Introduction

Some 1995 & 1996 Tacomas and 1996 4Runners may exhibit a slight "buzzing" noise, heard from the EVAP charcoal canister, when the engine is turned off after driving. To minimize this noise, the EVAP Canister Outlet Hose has been changed to incorporate a 50 cc air chamber.

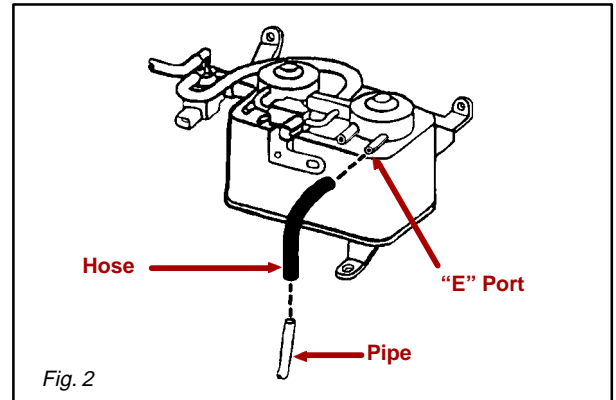
1. Hose Removal:
 - Remove original hose between “E” port and steel pipe (discard hose).

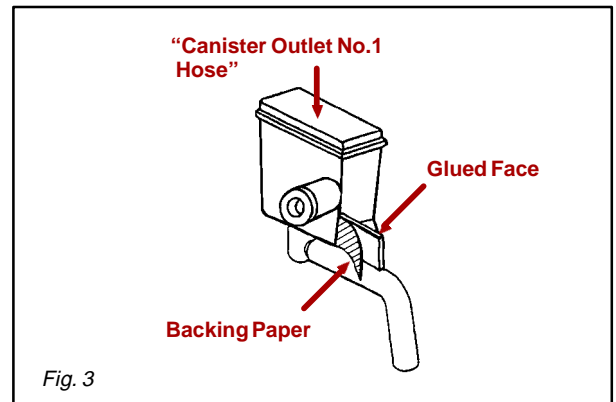
2. Canister Outlet No.1 Hose Installation.

- (a) Peel and remove backing paper from mating surface of canister chamber as shown.

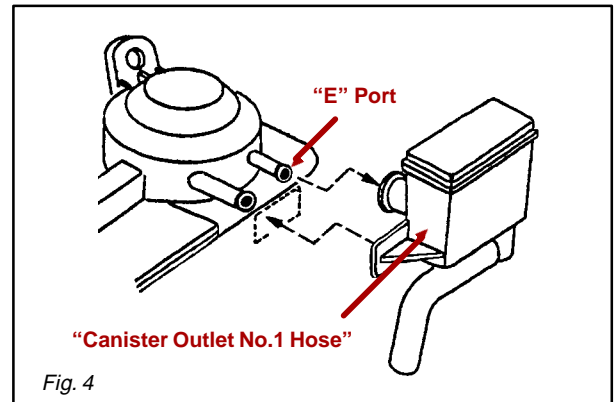
- (b) Connect and secure the Canister Outlet No.1 Hose to “E” port, then attach the air chamber to the canister body by firmly pressing the adhesive area against the canister body.

NOTE:
To insure proper adhesion, clean the mating surface of the canister body with alcohol prior to installation of the Canister Outlet No.1 Hose Assembly.

- (c) Connect the canister chamber outlet hose to the steel pipe as shown.
